Project # 25005 – SJCPL Western Branch Renovation/Addition
323 S Sheridan Street, South Bend, IN 46619

ADDENDUM No. 1

September 10th, 2025

3 WALL SECTION
3/4" = 1'-0"

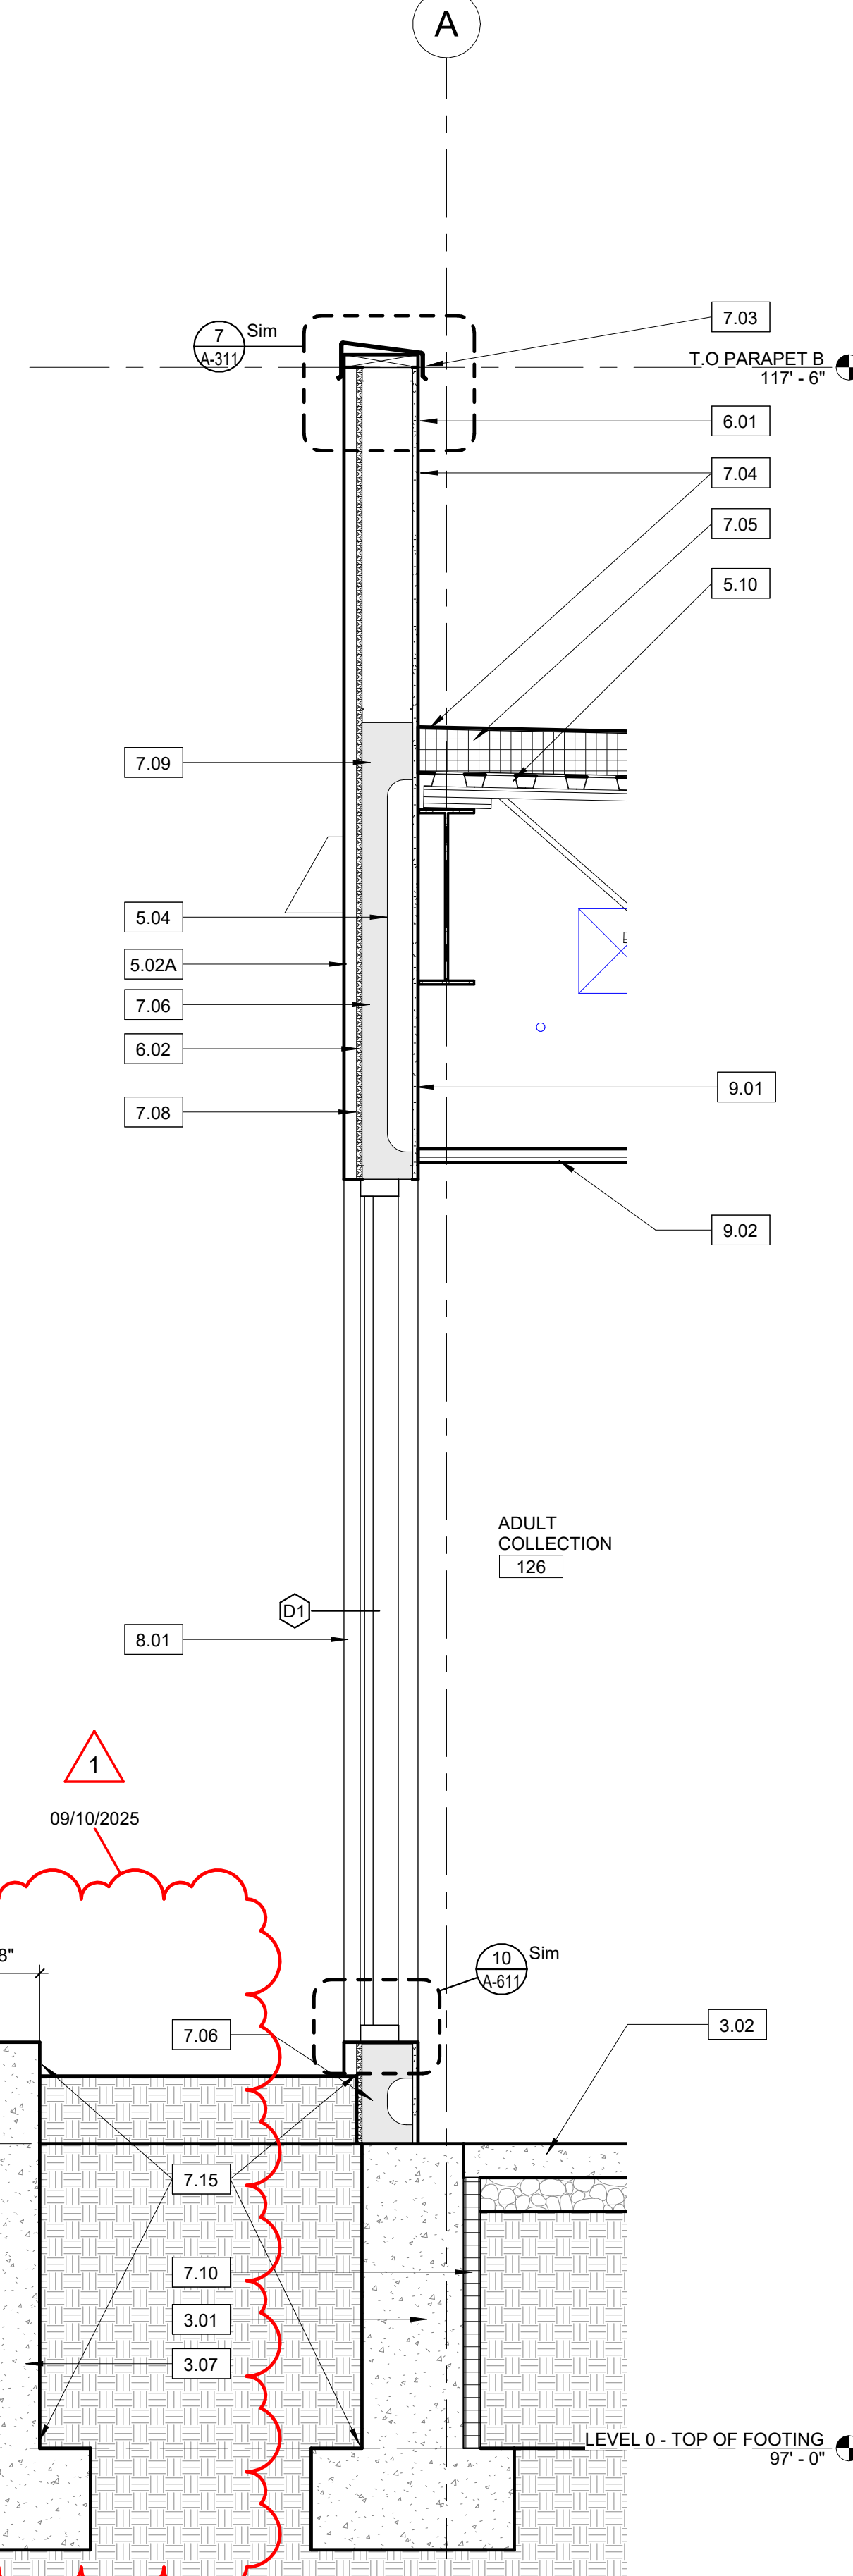
- iii. **Modification:** Section 3/A-311 – replace keynote 7.12 with 7.06 to indicate wall insulation shall be spray foam insulation.
- (c) **Sheet A-312: WALL SECTIONS**

2 WALL SECTION
3/4" = 1'-0"

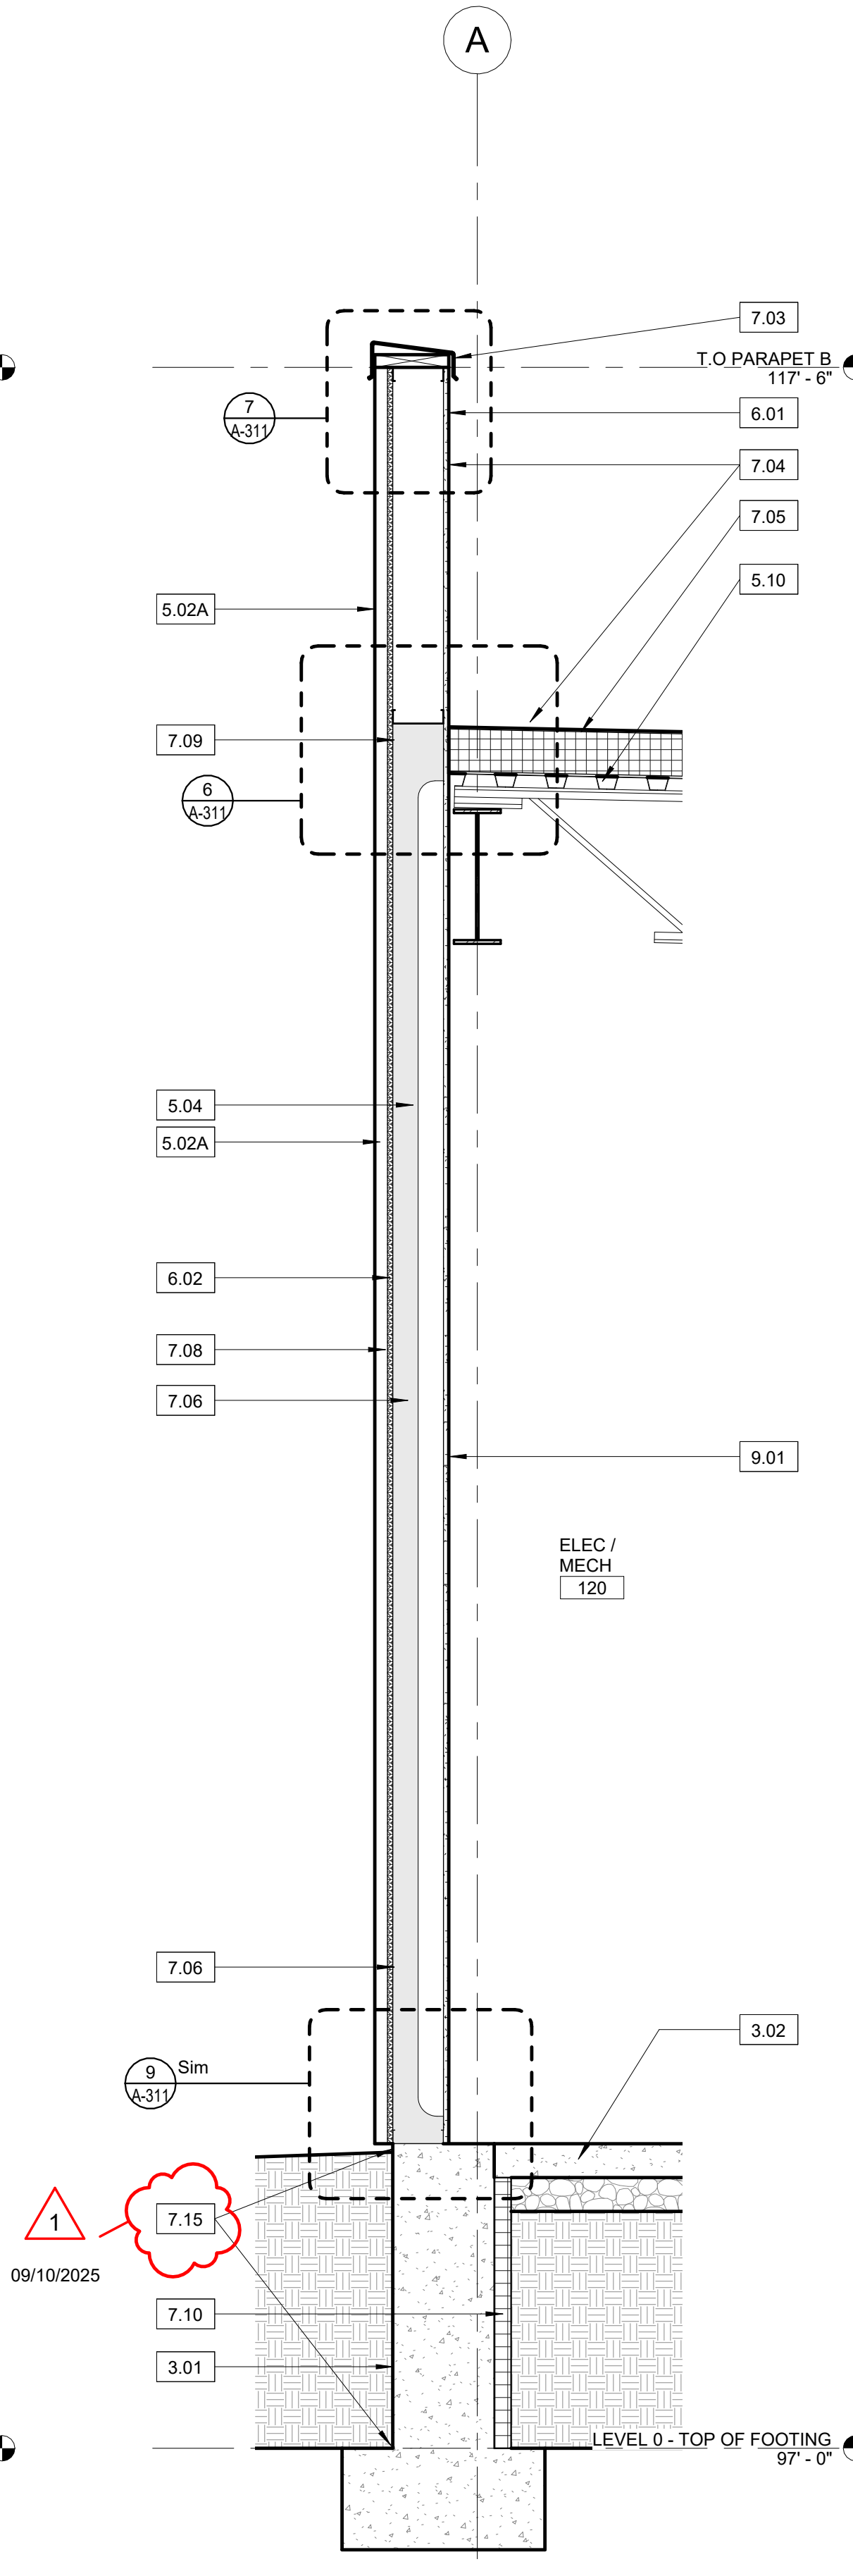
- (b) **Sheet A-311: WALL SECTIONS**
 - i. **Add:** Add keynote 7.15 at face of foundation walls to show location of waterproofing.
 - ii. **Add:** Section 2/A-311 – keynotes added at the concrete landscaping stem wall.

11 CIRC. DESK SECTION
1 1/2" = 1'-0"

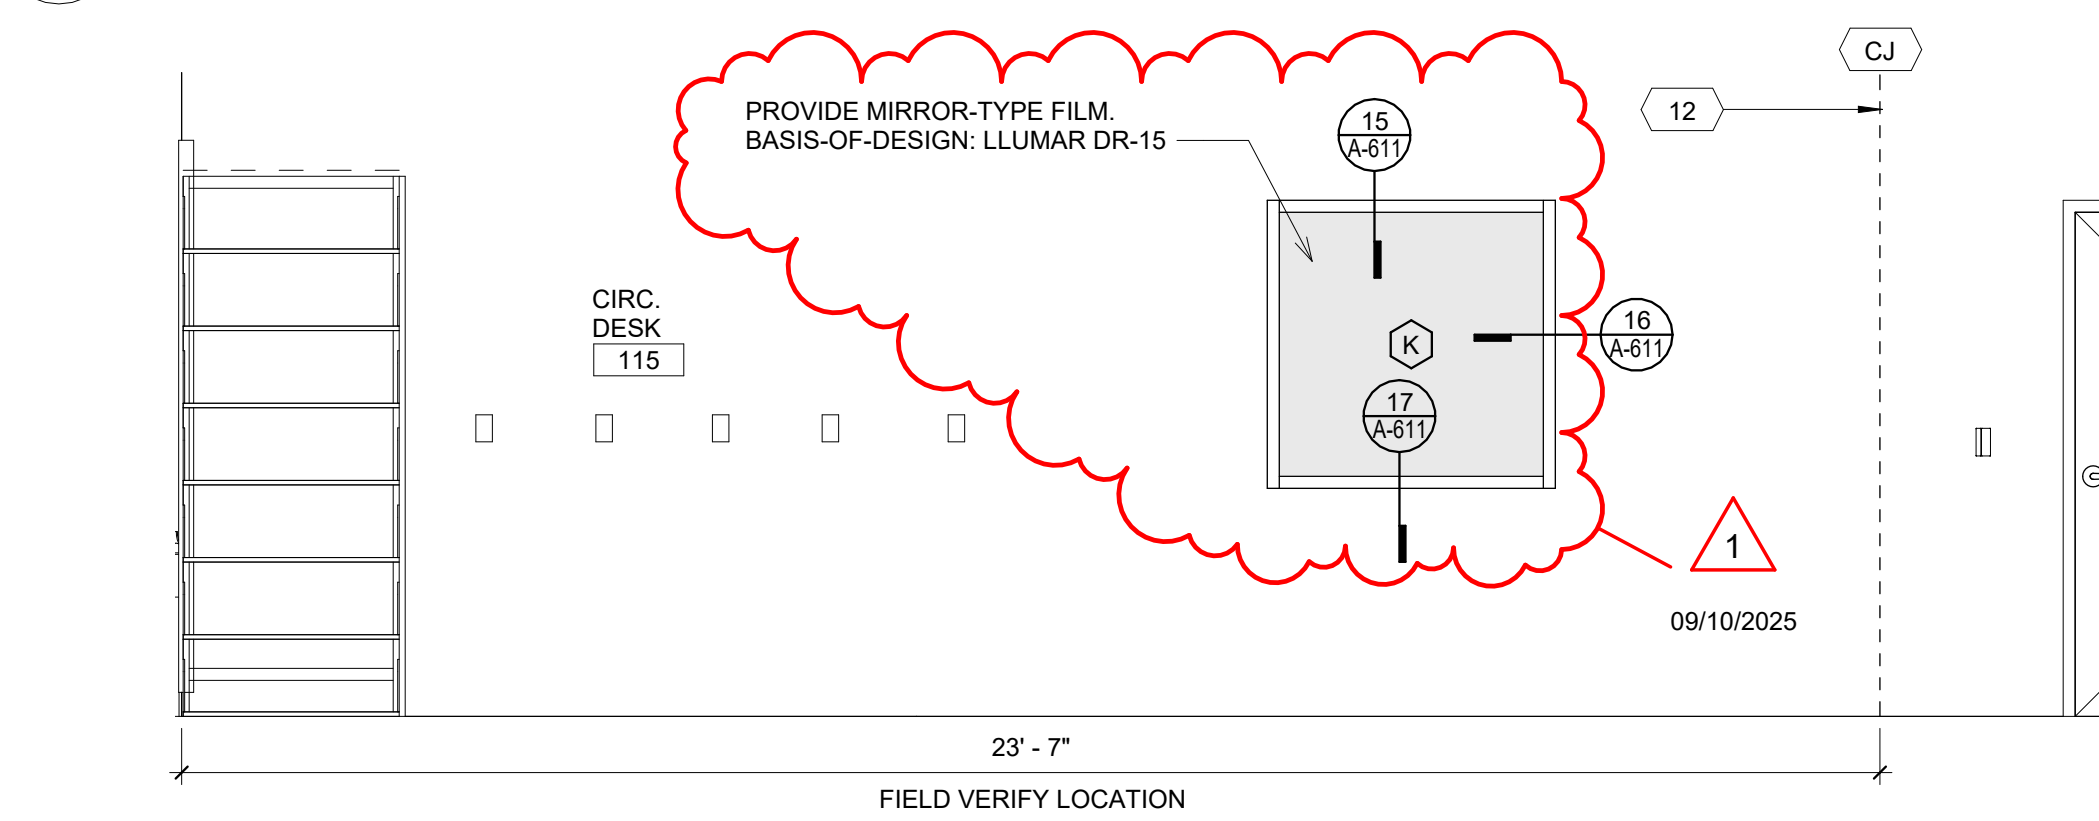
- ii. **Clarification:** Section 11/A-401. Additional note(s) on materials. See attached.
- (e) **Sheet A-406: INTERIOR ELEVATIONS**
 - i. **Clarification:** Elevations cleaned up to remove excess mechanical equipment documentation.

8 BACK CIRC. DESK
3/8" = 1'-0"

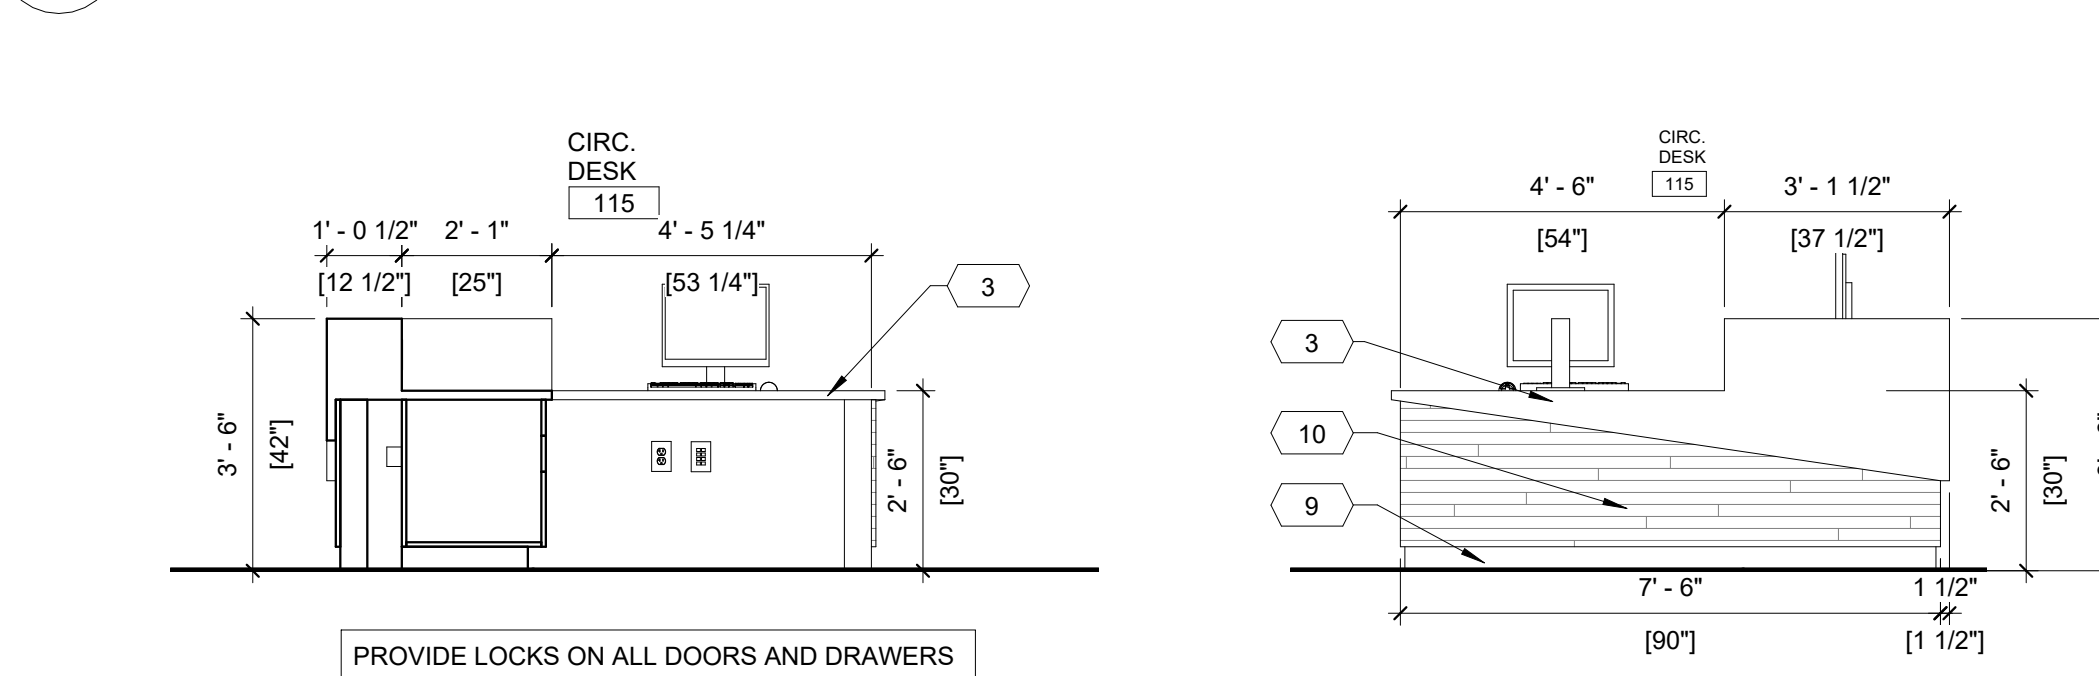
- (d) **Sheet A-401: ENLARGED PLANS & INTERIOR ELEVATIONS**
 - i. **Clarification:** Elevation 8/A-401. Provide window film basis-of-design: Llumar DR-15 on interior window “K”.

1 FIRST FLOOR LIGHTING PLAN
1/8" = 1'-0"

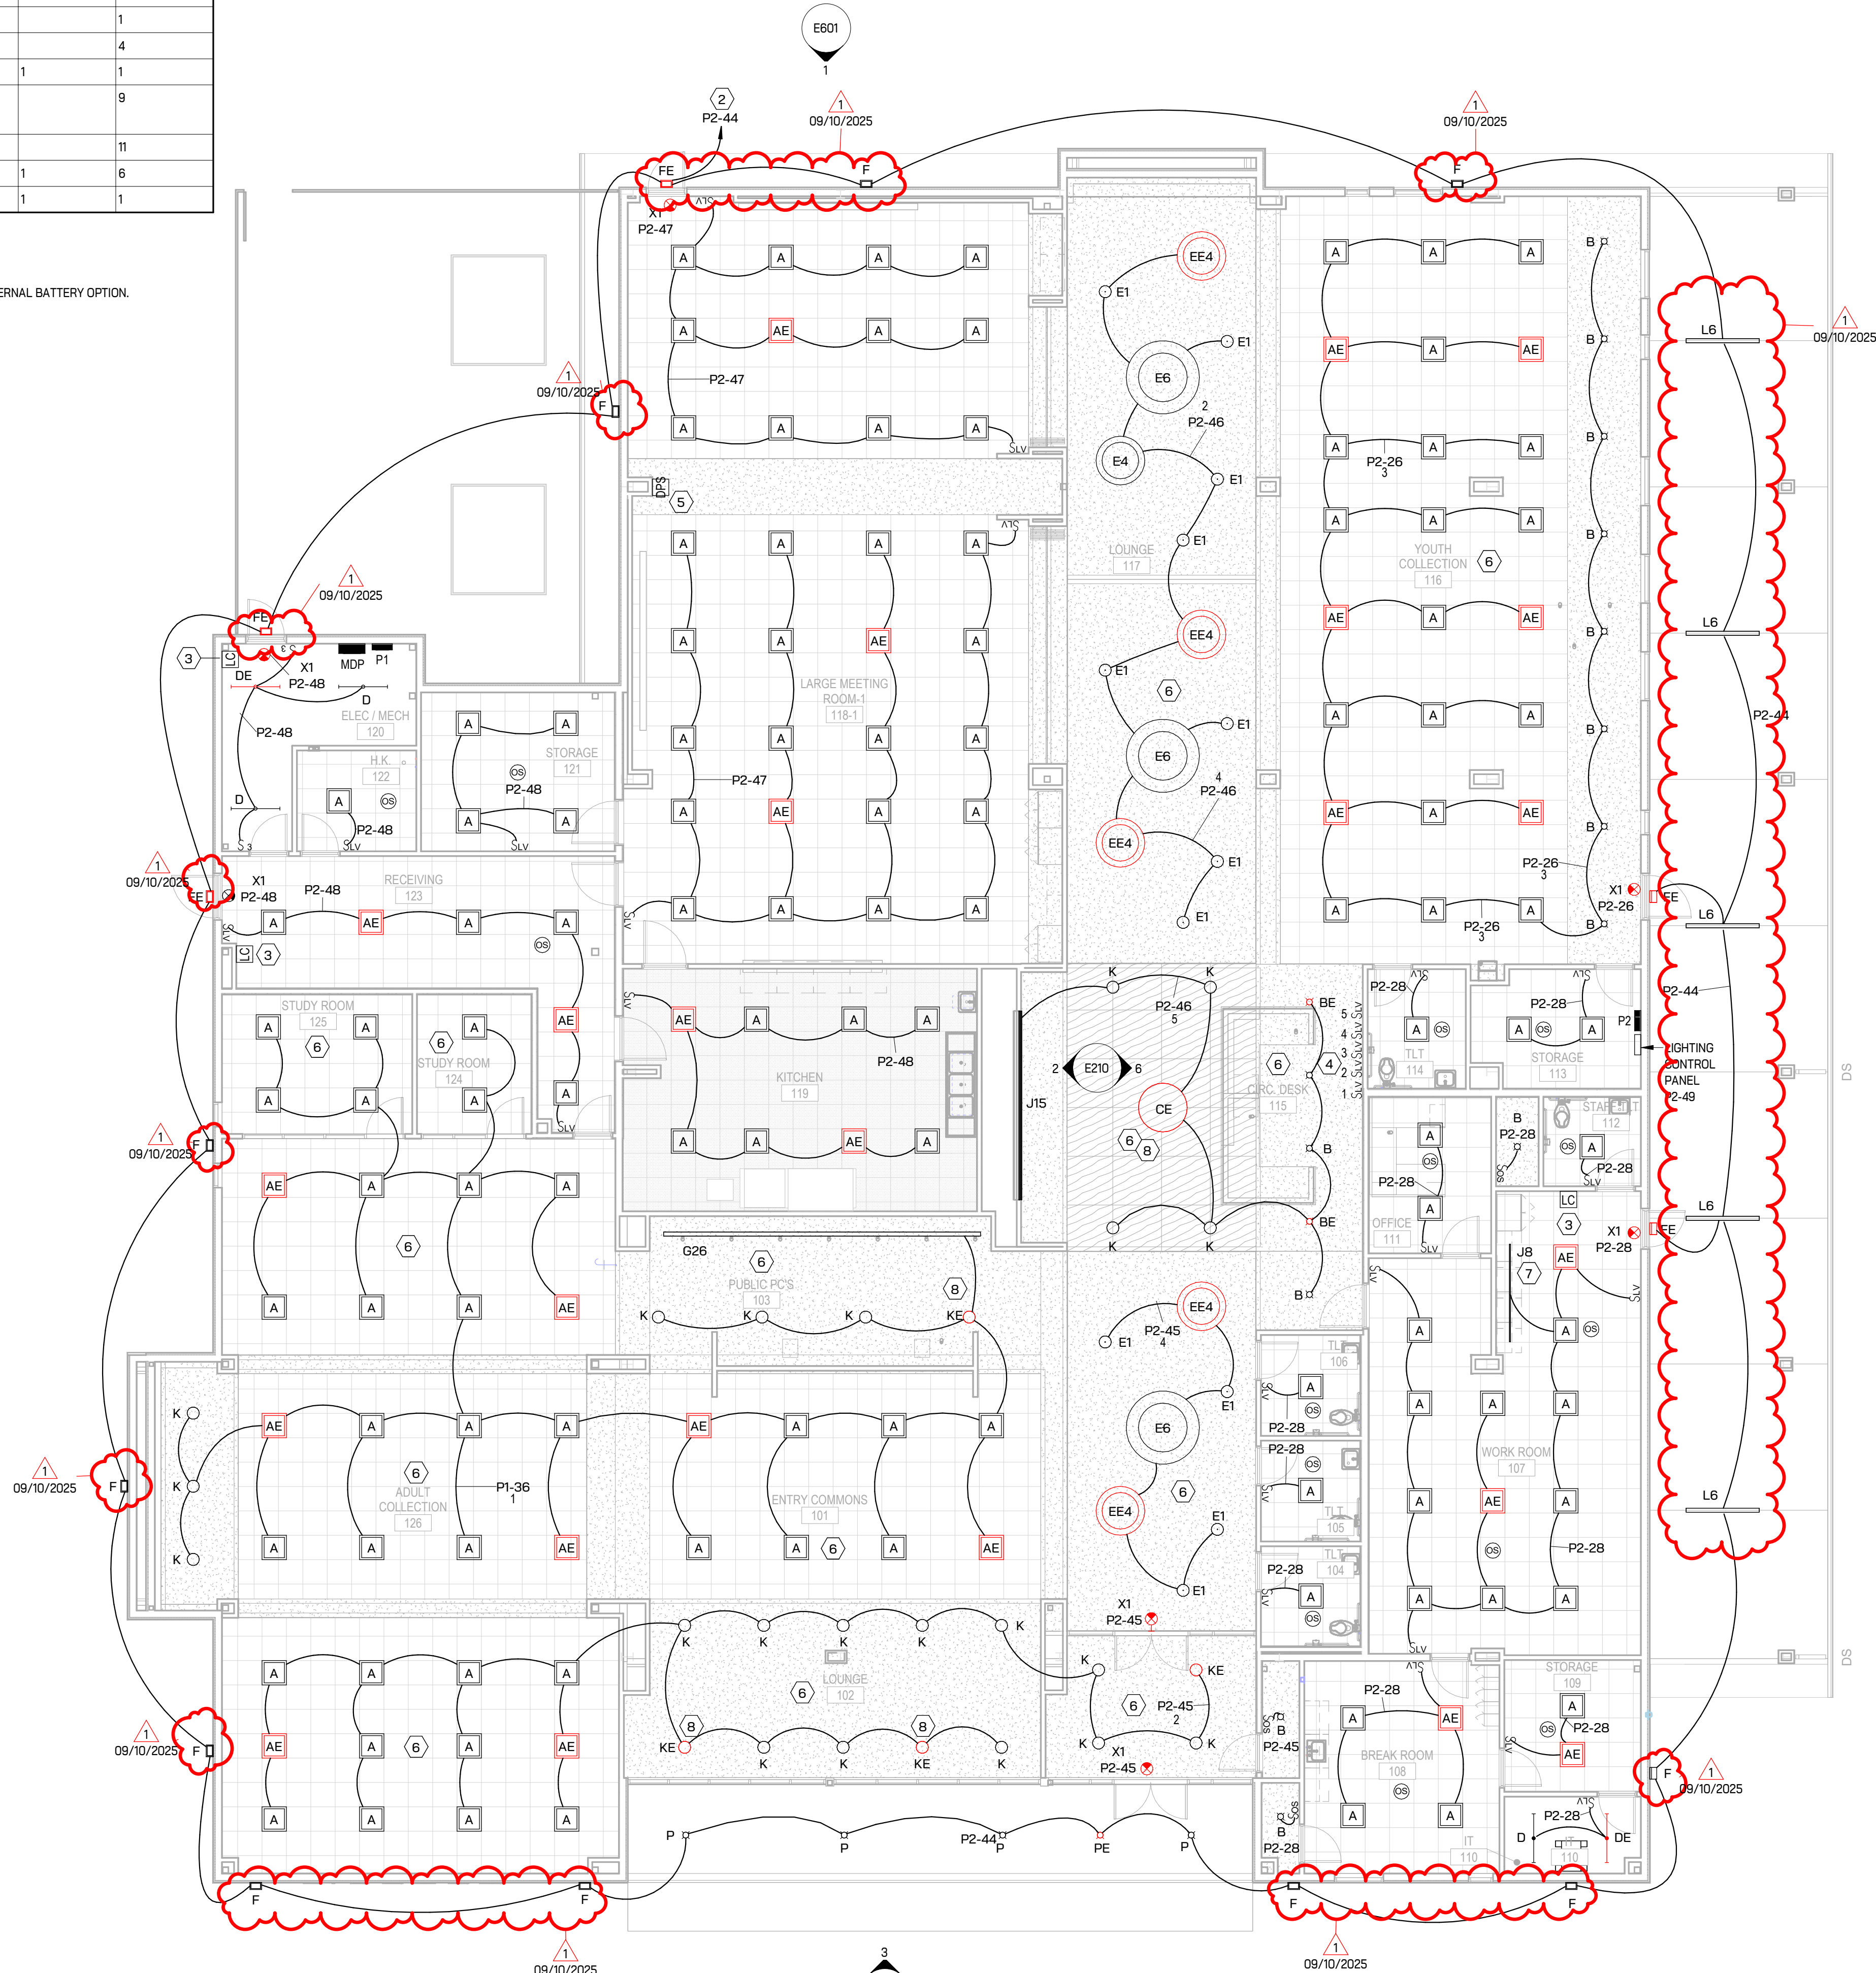
- H. Sheet E210 – First Floor Lighting Plan (reissued).
 1. **Modification:** Revised exterior lighting layout to show linear pendants and wall pack lights.

2. **Modification:** Revised basis of design of lighting fixtures for E1, E4, E6, EE4, and EE6.
- I. Sheet E211 – First Floor Emergency Lighting Plan (reissued).
